Subject: Submission - D/2025/1198 - 16-22 Cooper Street SURRY HILLS NSW 2010 - Attention Nick Reid

D/2025/1198 – 16-22 Cooper Street, Surry Hills – Public Exhibition Submission

Demolition of existing buildings, construction of an eight-storey mixed-use building over two levels of basement car parking, comprising of ground level retail and ten residential apartments at Level 1 to Level 7, landscaping and associated infrastructure, Stratum Subdivision into three Stratum lots and then Strata Subdivision of the Residential Stratum into ten Strata Lots.

1. Photos of impacted interface (south-west corner highlighted)
-

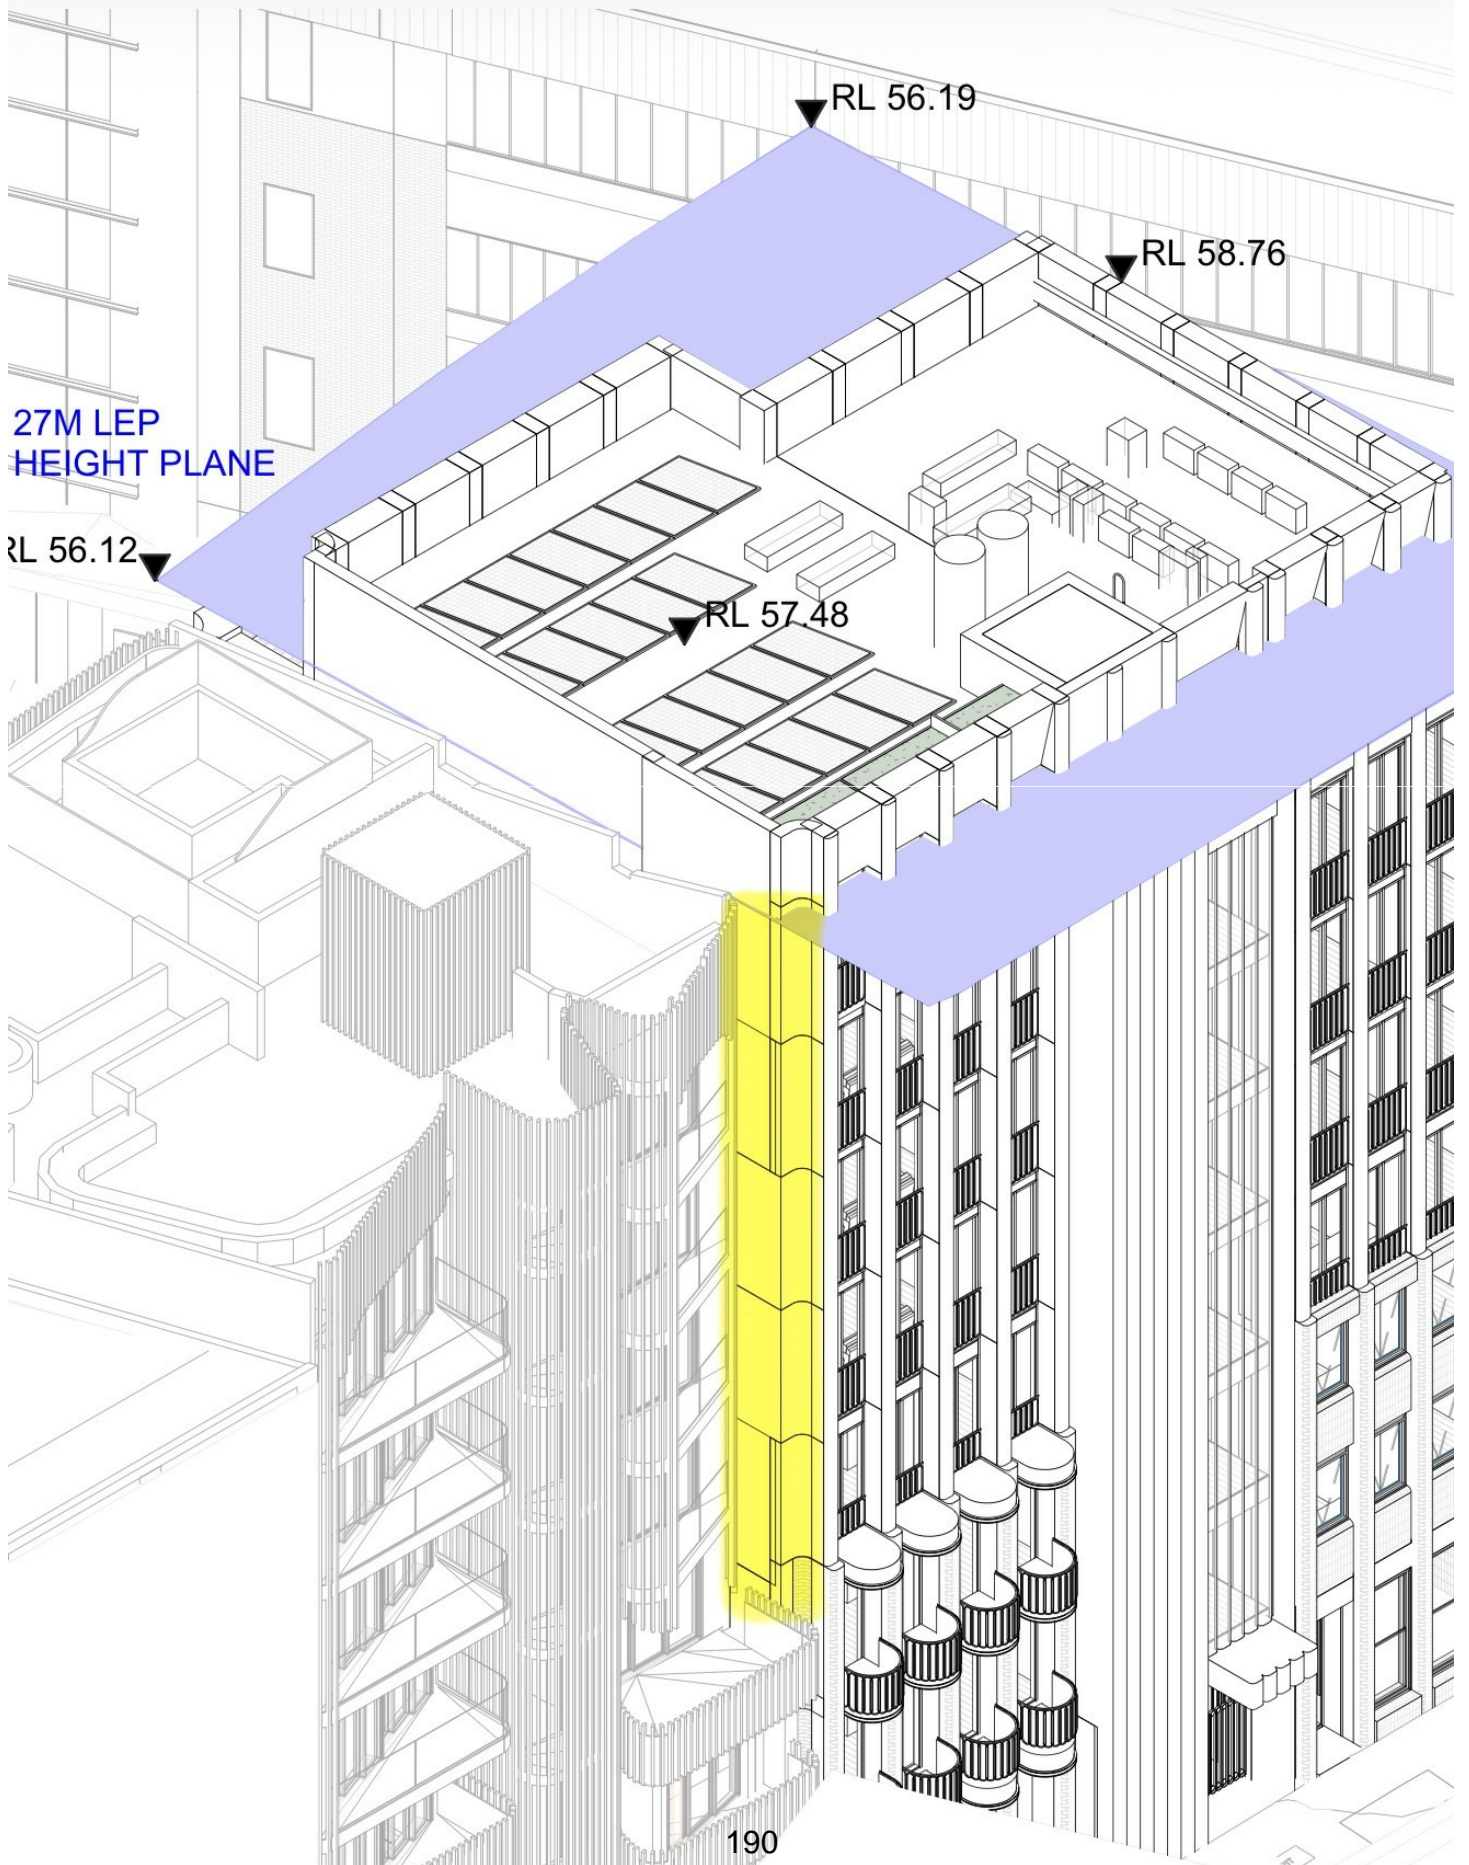
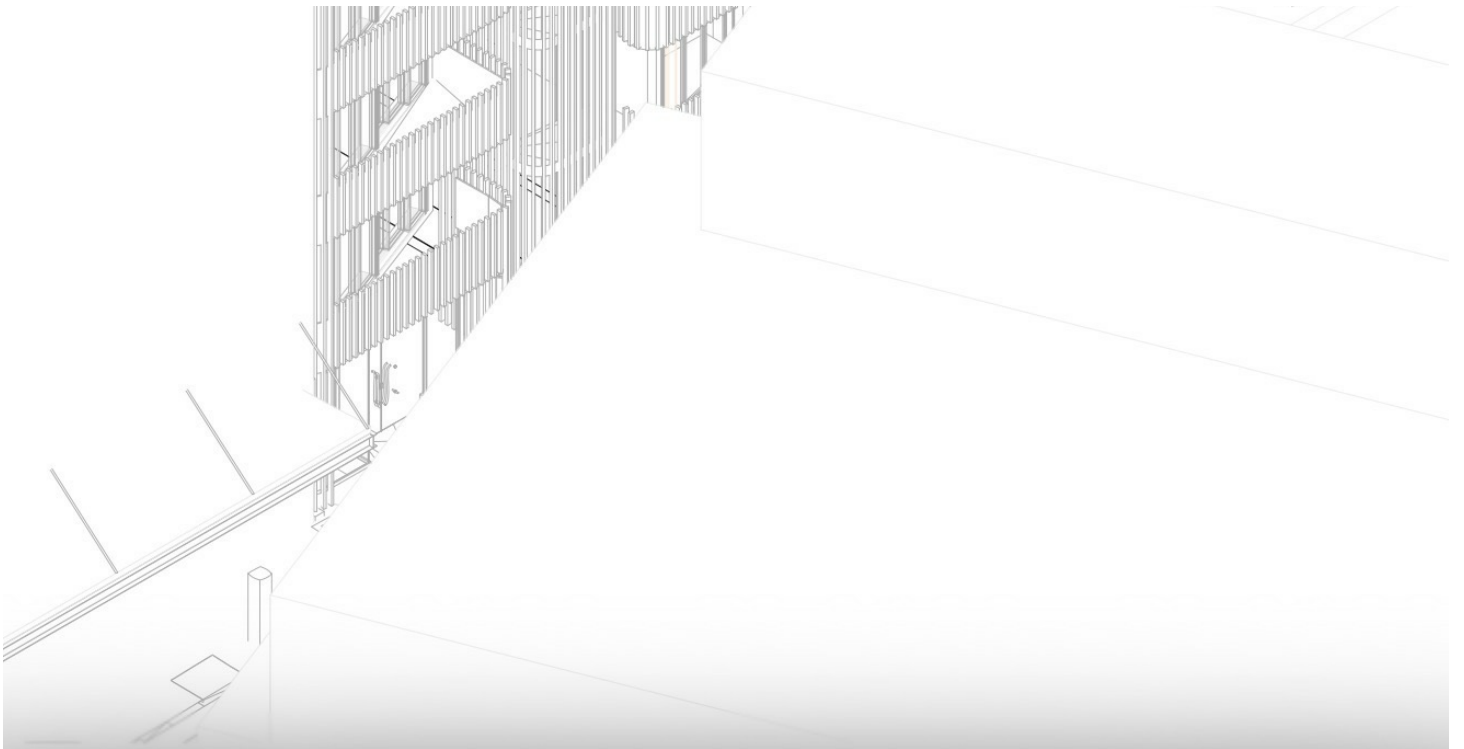
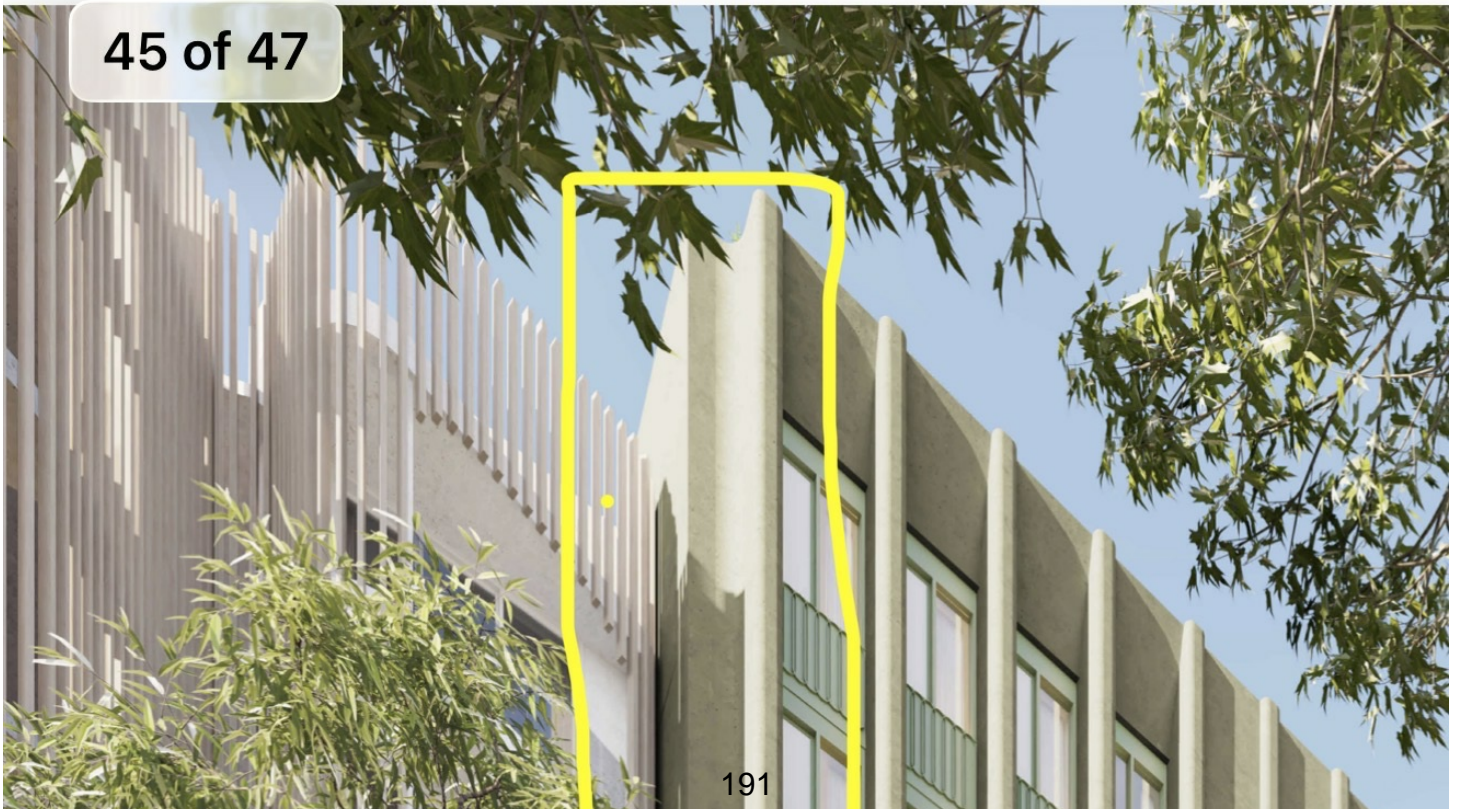
The proposal presents as a full-height wall built hard to the boundary at the south-west corner, with no meaningful upper-level setback to manage bulk. This results in an unreasonable loss of outlook, sky view and daylight access to my Level 4 balcony, **replacing an open streetscape outlook with a near-field wall condition**. The outcome is inconsistent with the intent of the DCP street wall controls, Apartment Design Guide amenity principles (as a benchmark), and reasonable expectations of adjoining development.

I do not object to a development that mirrors the general profile of my building and finishes in line with my Level 4 balcony. I object to the building extending beyond that line and presenting as an unrelieved wall directly opposite my apartment.

1. Refuse the application unless amended to introduce a meaningful upper-level setback or step at the Cooper Street south-west corner to reduce bulk and protect adjoining residential amenity; and
2. Refuse the Clause 4.6 height variation and require compliance with the 27m LEP height limit.

Alternatively, should Council be minded to consider approval, I request that further neighbour-specific impact analysis be required prior to determination, including verified visual, sky view, daylight and privacy impacts from Level 4 of 10–14 Cooper Street.
